*MWO 11-5820-298-35/1

DEPARTMENT OF THE ARMY MODIFICATION WORK ORDER

MODIFICATION OF RADIO RECEIVERS R-274A/FRR (HAMMARLUND MODEL SP-600-JX), AND R-320A/FRC (HAMMARLUND MODEL SP-600-J) TO PROVIDE MORE ADEQUATE FUSING OF THE POWER TRANSFORMER AND TO PROVIDE BETTER ACCESSIBILITY TO THE B MINUS FUSE

MODIFICATION OF RADIO RECEIVERS R-274A/FRR,
R-274C/FRR, R-320A/FRC, AND THE HAMMARLUND
RADIO RECEIVERS SP-600-JX AND SP-600-JLX,
TO IMPROVE SIGNAL-TO-NOISE RATIO ON AGC OR
MGC OPERATION AND TO PREVENT BLOCKING OF
THE FIRST MIXER TUBE

Figure 1. Location of spare fuseholders and decalcomanias.

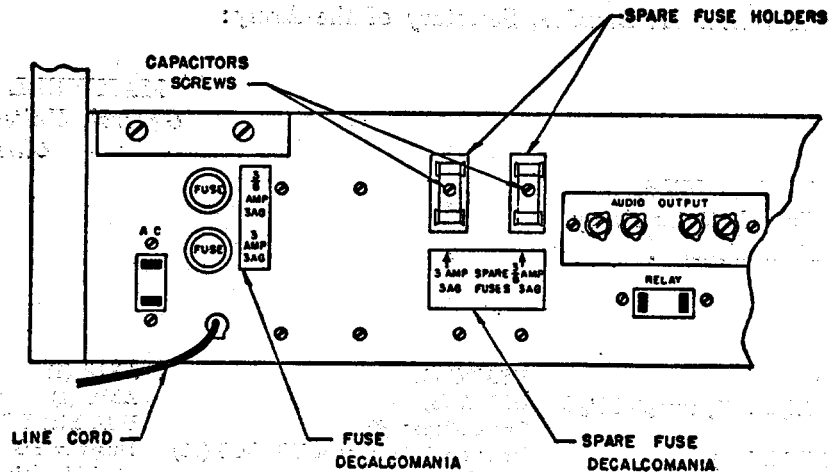
3. Purpose of Modification. a. To prevent frequent blowouts of power fuse F1 by substituting a 3-ampere fuse for the 2-ampere fuse.

b. To prevent frequent blowouts of B minus fuse F2 by substituting a ½-ampere fuse for the ¼-ampere fuse.

c. To provide better accessibility to B minus fuse F2 by relocating it in the SPARE fuseholder adjacent to fuse F1.

- g. Remove the word SPARE which is adjacent to the spare fuseholder.
- h. Apply the fuse decalcomania in the position shown in figure 1.
- i. Insert a 3/8-ampere fuse in the newly wired fuseholder in accordance with instructions on the new decalcomania.

- k. Remove the nuts, lockwashers, and screws that hold the top end of capacitors C151 and C160 (fig. 1) to the inside of the rear chassis wall.
- l. Mount the two spare fuseholders in the position shown in figure 1. Use two new No. 6-32 thread \times 1/2-inch long binding-head machine screws and the original lockwashers and nuts.

- m. Apply the spare fuse decalcomania in the position shown in figure 1.

Figure 2. Circuit diagram for modified portion of the radio receiver.

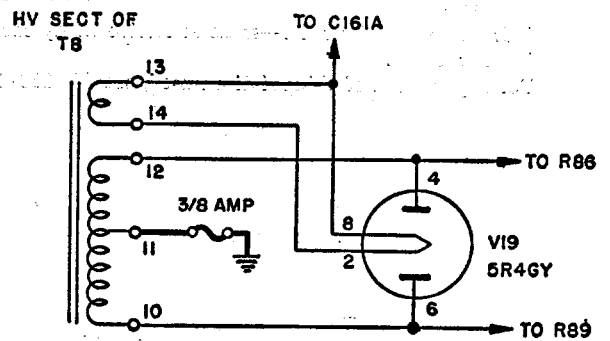
NOTE:
HEAVY LINES DENOTE CHANGES

Figure 2. New locations of resistors R72 and R73, and capacitors C152 and C168.

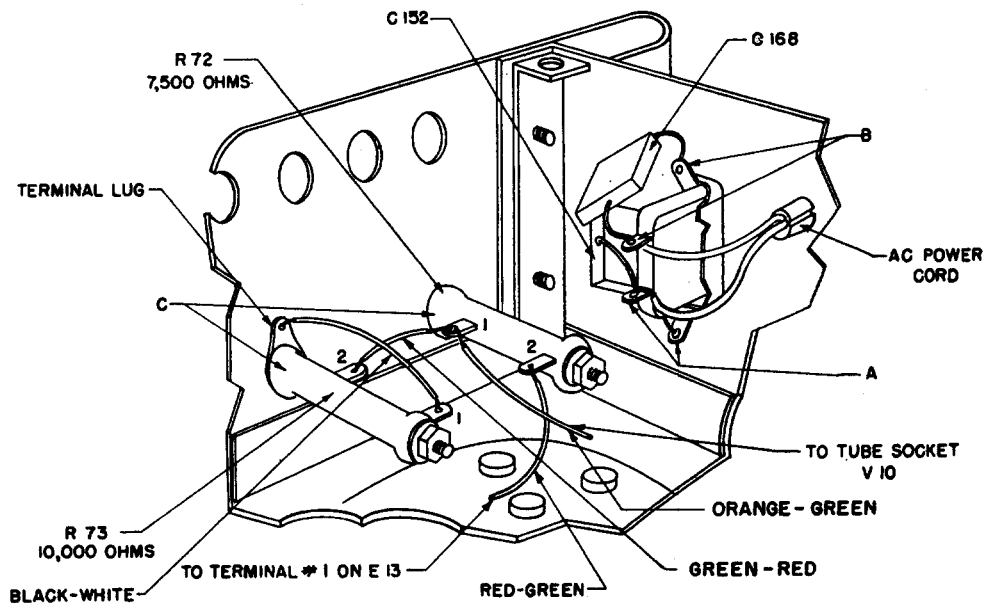
- (1) Mount new resistor R73 (10K ohm, 17w) at the location of one of the existing mounting holes previously used to support dual capacitor C152, as shown at C, figure 2. Use a No. 6-32 x 2½-inch-long RHM screw, washers, terminal lug, and nut, as shown at B, figure 1.

- (2) Mount new resistor R72 (7.5K ohms, 17w) at the location of the other existing mounting hole previously used to support dual capacitor C152, as shown at C, figure 2. Use a No. 6-32 x 2½-inch-long RHM screw, washers, and nut, as shown at B, figure 1.

- (3) Connect and solder a suitable length of No. 22 AWG black-white wire between terminal No. 1 of resistor R73 and the terminal lug, as shown at C in figure 2.

- (4) Connect and solder a suitable length of No. 22 AWG green-red wire between terminal No. 1 of resistor R72 and terminal No. 2 of resistor R73, as shown at C, figure 2.

Figure 3. New component and wiring changes at terminal board E17.

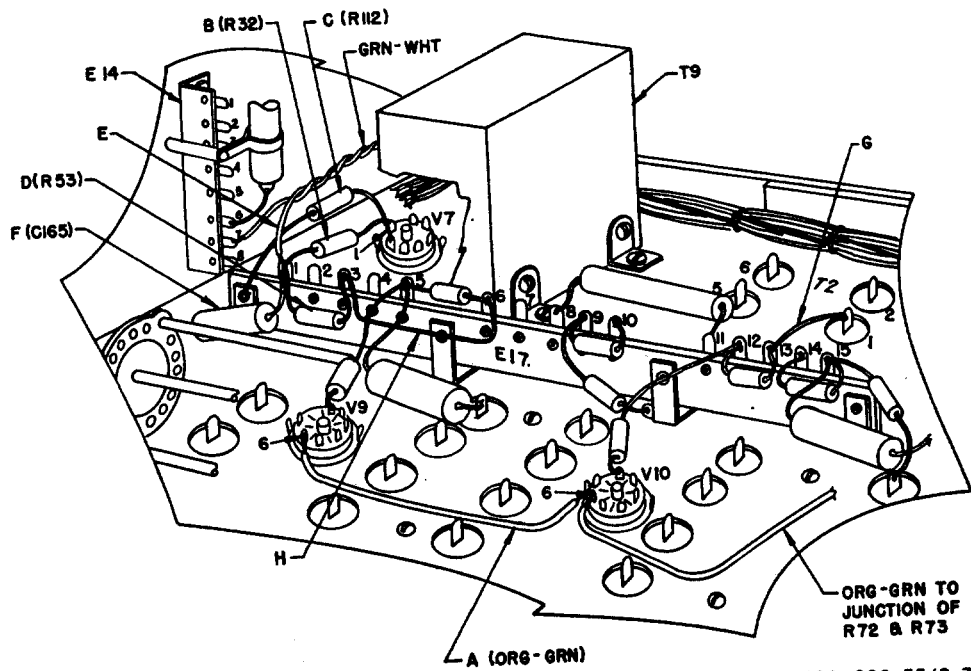
- (7) Connect and solder a suitable length of No. 22 AWG orange-green wire between pin No. 6 of tube socket V9 and pin No. 6 of tube socket V10, as shown at A, figure 3.

directly to ground. In these receivers, remove the ground leads, and connect and solder a new 390-ohm resistor (R112) between pin No. 7 of tube socket V7 and the ground terminal of terminal board E17, as shown at C, figure 3. Connect and solder a new ground lead between pin No. 2 of tube socket V7 and the adjacent ground terminal.

- (3) Connect and solder a new 10K-ohm resistor (R53) between terminals No. 1 and No. 3 of terminal board E17, as shown at D, figure 3, if this resistor does not already exist, or if it is of a value other than 10K ohms.
- (4) Unsolder and remove the green-white lead from terminal No. 8 (ground lug) of terminal board E14, and connect and solder this lead to terminal No. 1 of terminal board E17, as shown at E, figure 3.
- (5) Connect and solder a .01-mfd, 600-volt, tubular capacitor (C165) between terminal No. 1 of terminal board E17 and ground, as shown at F, figure 3, if capacitor C100 is not already installed in the same position.
- (6) Unsolder and remove the blue-white lead connected to terminal No. 1 of

- (7) Connect and solder a suitable length of No. 22 AWG white-black wire between terminal No. 1 of transformer T2 and terminal No. 13 of terminal board E17, as shown at G, figure 3.

Figure 4. Original location of capacitor C163.

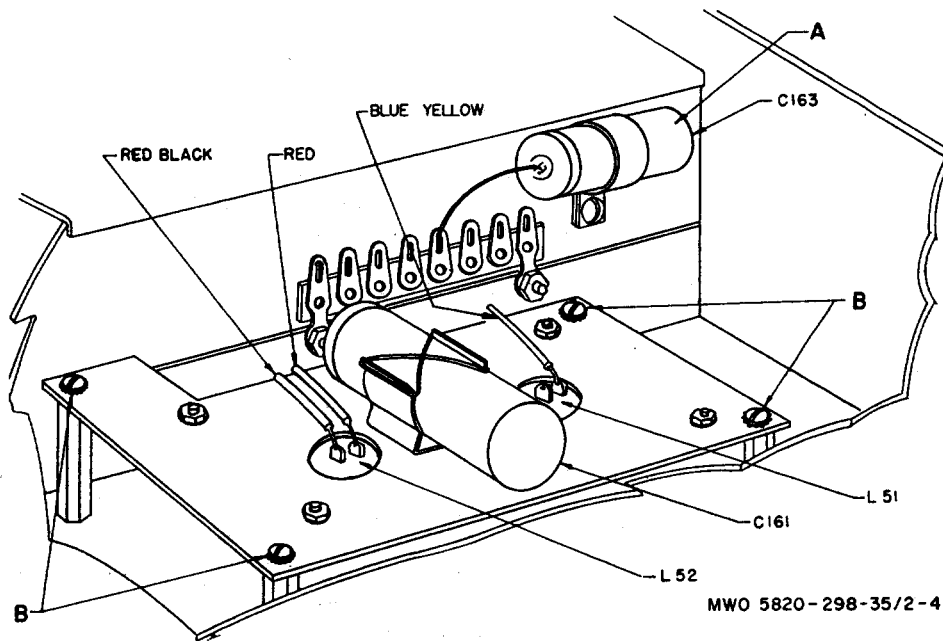
- modified for the presence of the .25 mfd capacitor (C163) in the position shown at A, figure 4. If one exists, remove it as explained below.
- (2) Remove the 15 screws and lockwashers that hold the bottom cover to the tuning unit housing and remove the cover.
 - (3) Remove the screw, lockwasher, and nut that hold the capacitor to the tuning unit housing and remove the capacitor.

- (5) Remove the four screws and lockwashers, shown at B, figure 4, that hold the power filter-choke subassembly to the chassis and lift the subassembly from the chassis. This will permit access to terminal board E13, and to the leads, for removal and replacement with the new terminal board E13.

Figure 5. Lead connections to new terminal board E13.

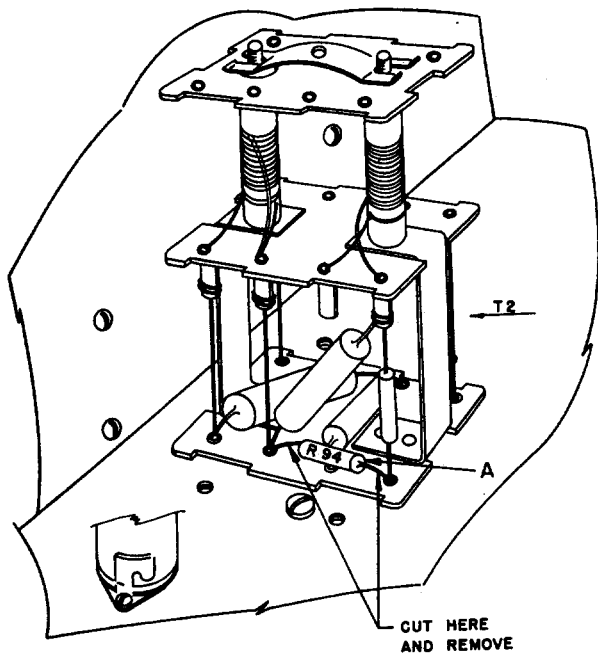
- (8) Mount new terminal board E13 in the position previously held by the old terminal board, using the original screws, lockwashers, and nuts.
 - (9) Connect and solder the leads removed from the old terminal board to the new terminal board in accordance with figure 5.

1-# THESE NUMBERS ARE FOR REFERENCE ONLY AND DO NOT APPEAR ON STRIP.
 2- FOR RECEIVERS BELOW MFR'S SERIAL NO. 7658 INCLUSIVE, CONNECT RED-WH LEAD TO TERMINAL 2; BLUE-RED LEAD TO TERMINAL 3. ABOVE 7658, CONNECT RED-WH LEAD TO TERMINAL 3 AND BLUE-RED LEAD TO TERMINAL 2.
 3- FOR COMMUNICATIONS CONNECT WHITE-BLACK LEAD TO TERMINAL 8. FOR DIRECTION FINDING USE, CONNECT TO TERMINAL 7.

Figure 7. Original wiring of RF strip.

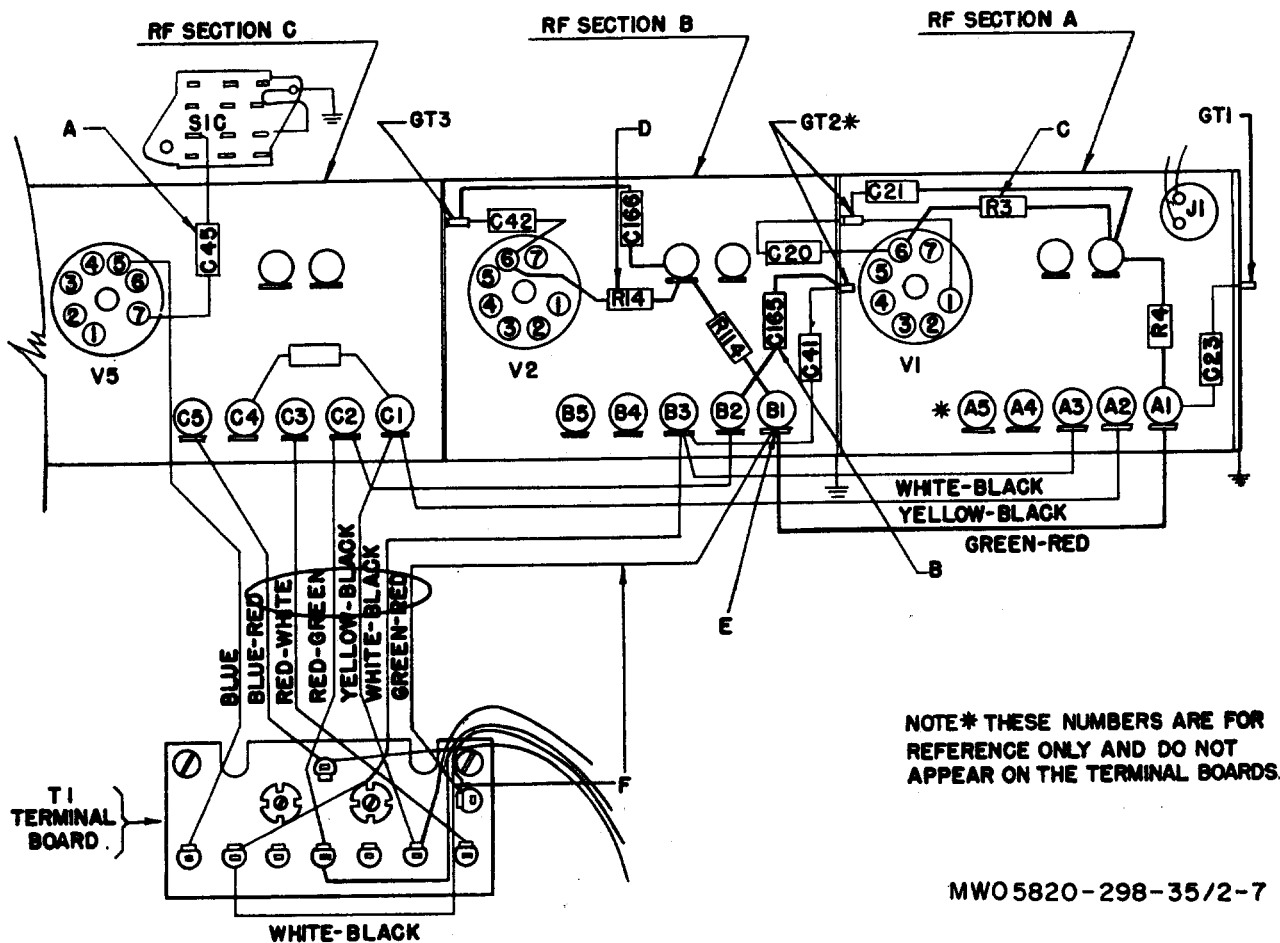
- (6) Remove the eight screws and lock-washers that hold the RF strip to the capacitor tuning unit housing and remove the RF strip.
- (7) Examine RF section C of the RF strip for the presence of capacitor C45 in the position shown at A, figure 7.

- (8) If capacitor C45 exists in this position, unsolder and remove the capacitor from pin No. 7 of tube socket V5 and terminal No. 6 of the ceramic switch stator S1C, as shown in figure 7.

- (10) Examine RF section B of the RF strip for presence of capacitor C165 in the position shown at B, figure 7.
- (11) If the capacitor is in this position, unsolder and remove the .01 mfd capacitor (C165) from terminal B2 of the RF strip and ground terminal GT2, shown at B, figure 7.

- (12) Check resistor R3 for proper resistance value. It is located in RF section A, and connected between pin No. 6 of tube socket V1 and the junction of resistor R4 and capacitor C21, as shown at C, figure 7. If this resistor is other than 33,000 ohms, replace it with a 33,000-ohm, 1/2-watt resistor.

Figure 8. New connection of RF strip.

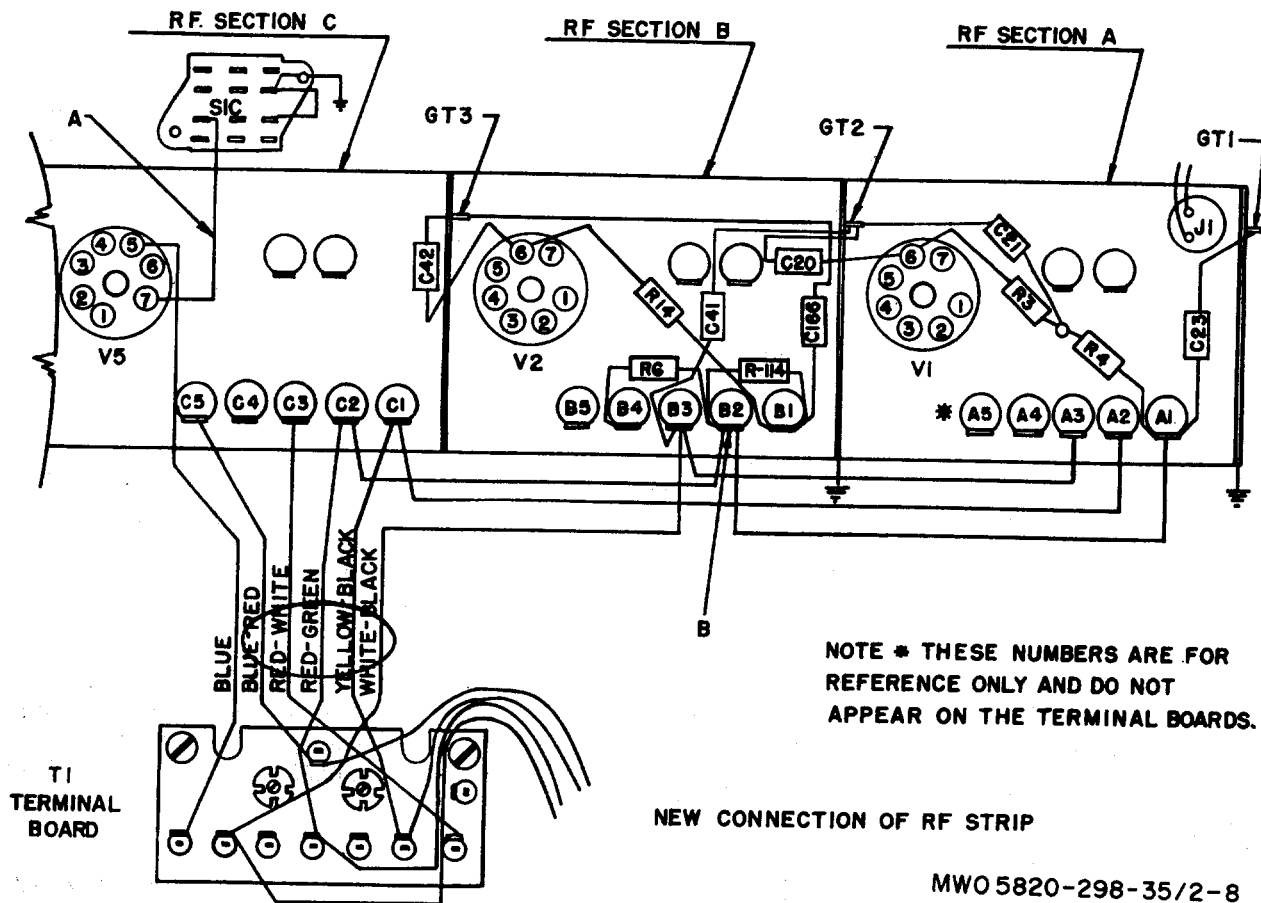
- (9) Connect and solder a suitable length of No. 22 AWG green-white wire between pin No. 7 of tube socket V5 and terminal No. 6 of the ceramic switch stator S1C, as shown at A, figure 8.

V2 and the junction of resistors R5 and R6. In these sets, resistor R14 should be reconnected in accordance with figure 8.

- (14) Connect and solder a .01 mfd, 600 vdcw tubular capacitor (C166) between terminal B1 and chassis ground terminal GT3, as shown in figure 8, if a capacitor is not already connected in this position.
- (15) Unsolder and remove the green-red lead connected to terminal B1, shown at E, figure 7 (the other end of the lead terminates at terminal A1), and connect and solder it to terminal B2, as shown at B, figure 8.
- (16) Unsolder and remove the green-red lead shown at F, figure 7 from terminal B1, and remove from the plastic sleeve.
- (17) Connect and solder a 1,000-ohm, 1/2-

watt resistor (R114) between terminals B1 and B2, as shown in figure 8, if a 1,000-ohm resistor is not at this location.
